ADDITION DAYTON HIGHSCHOOL ROOF ABATEMENT LOCATIONS

Dayton High School

Main Building Roof

Summer 2022 - ACM Abatement Locations

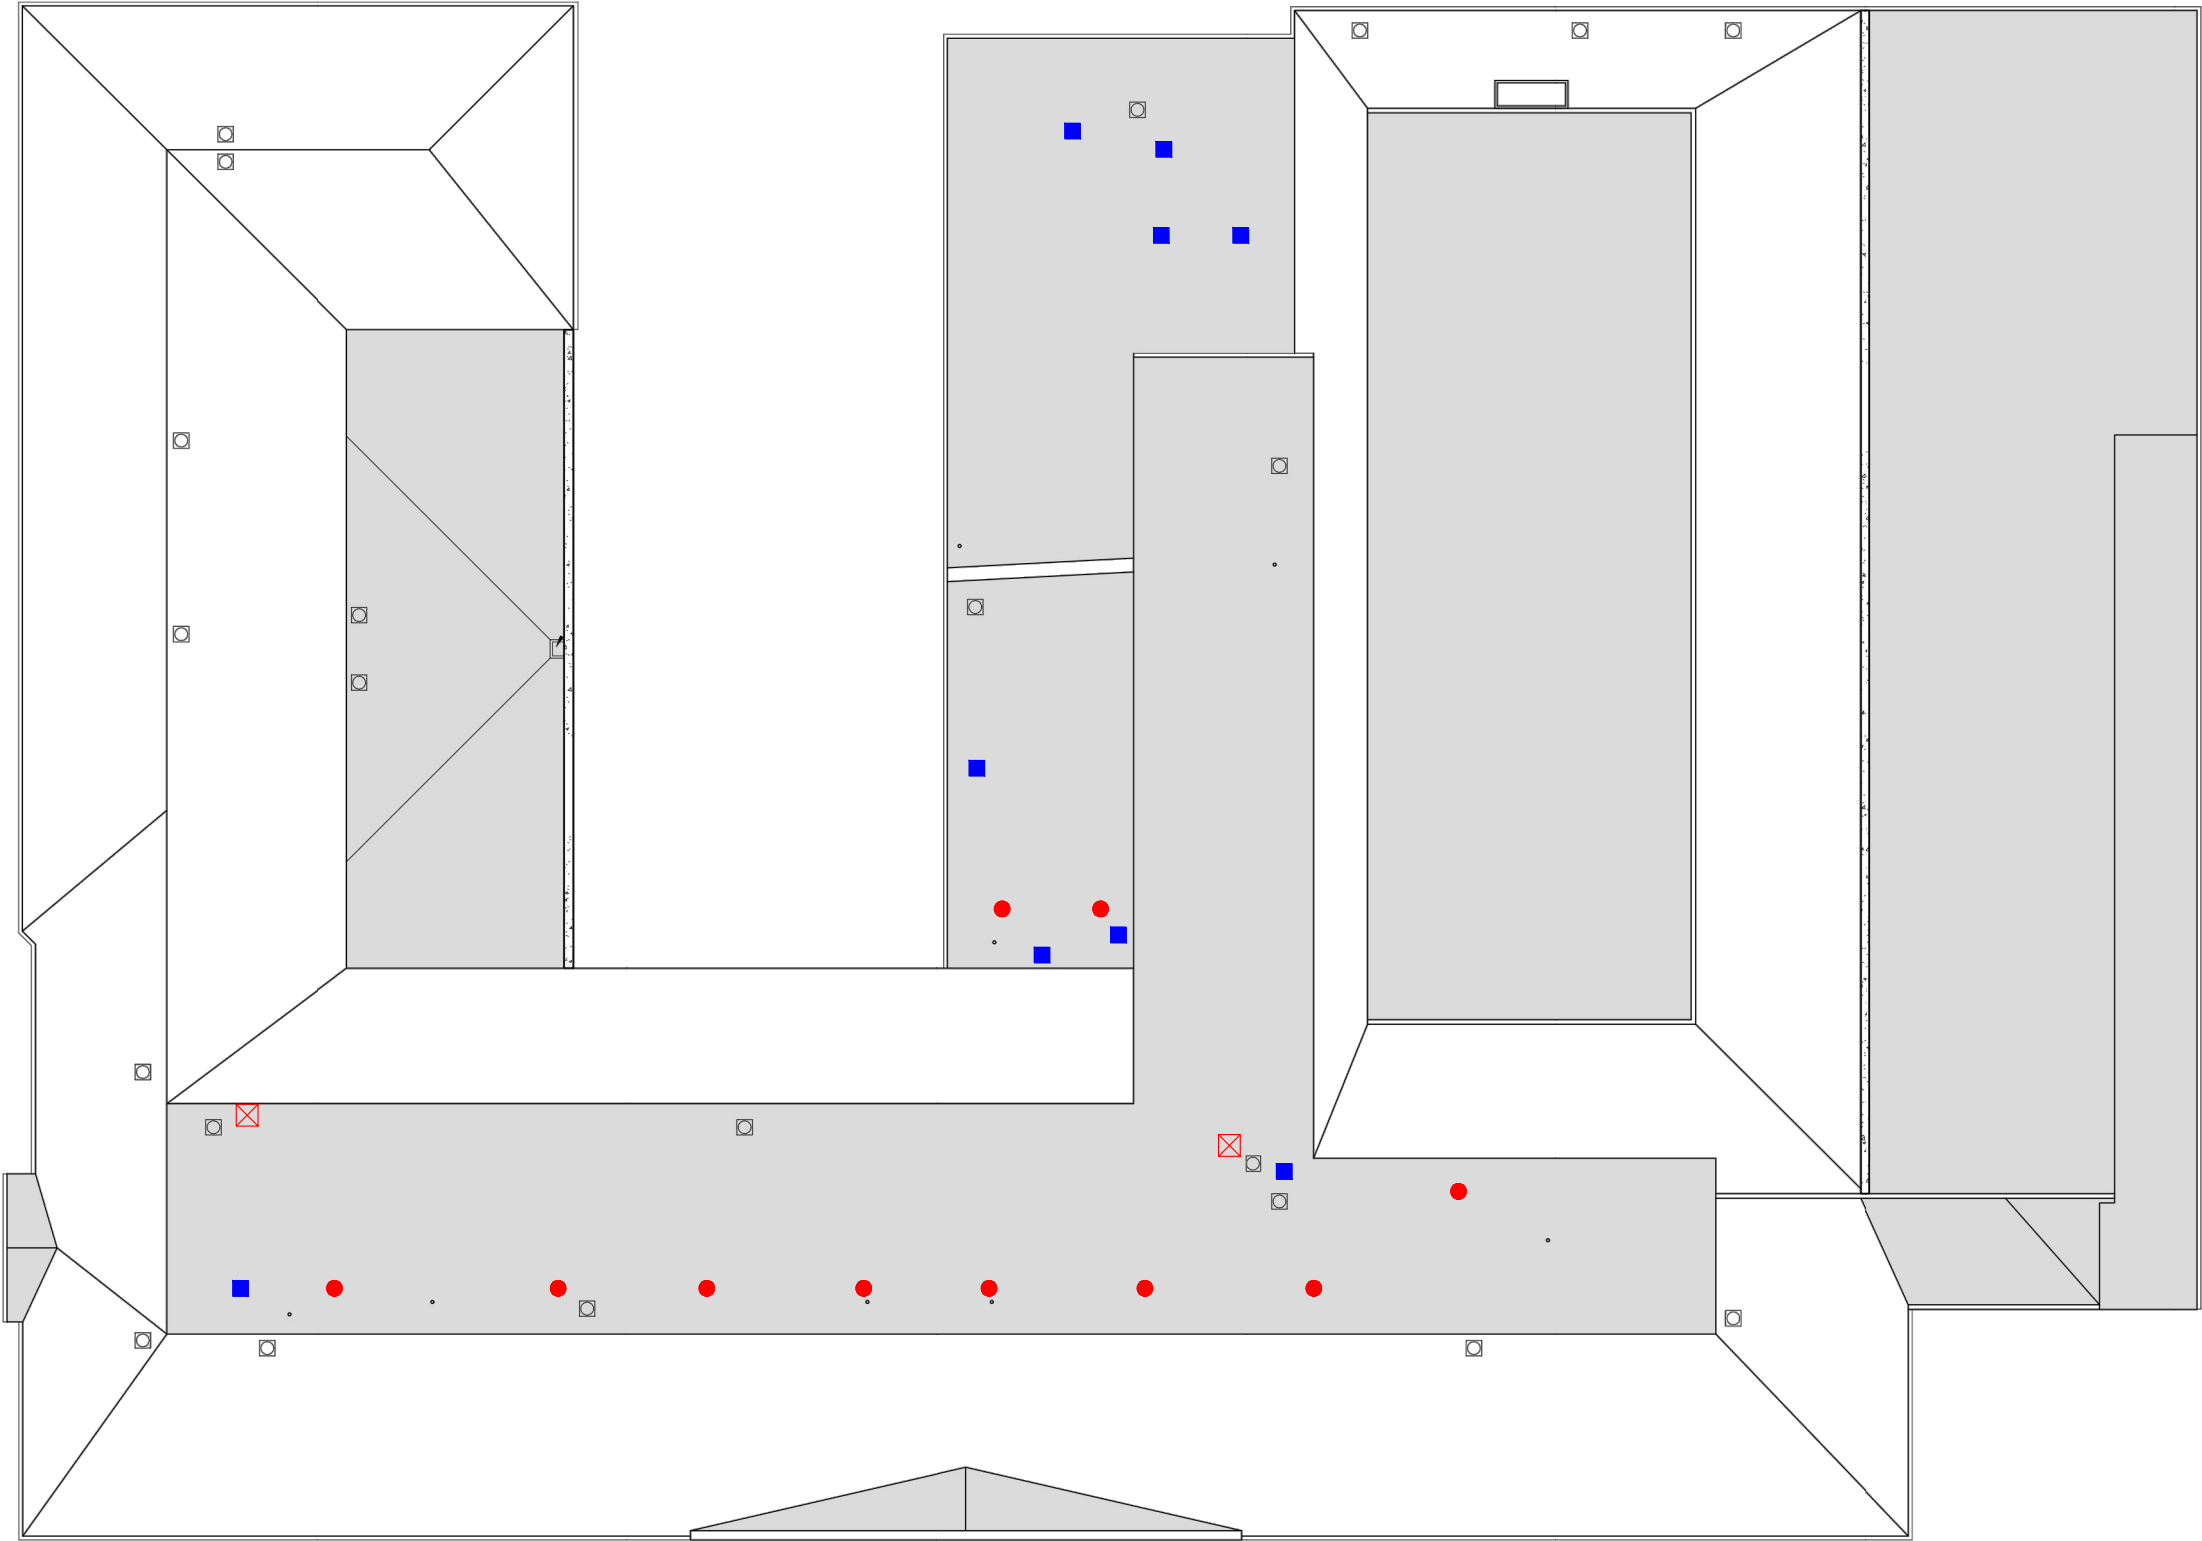
- Remove asbestos-containing sealant on and around exhaust vents - 45 sq. ft. (To be performed by roofing contractor)
- Remove asbestos-containing sealant on and around round HVAC vents - 60 sq. ft. (To be performed by roofing contractor)
- ⊠

Abate and remove roof access hatch with asbestos-containing silver paint and asbestos-containing sealant (To be performed by abatement contractor) - 40 sq. ft.
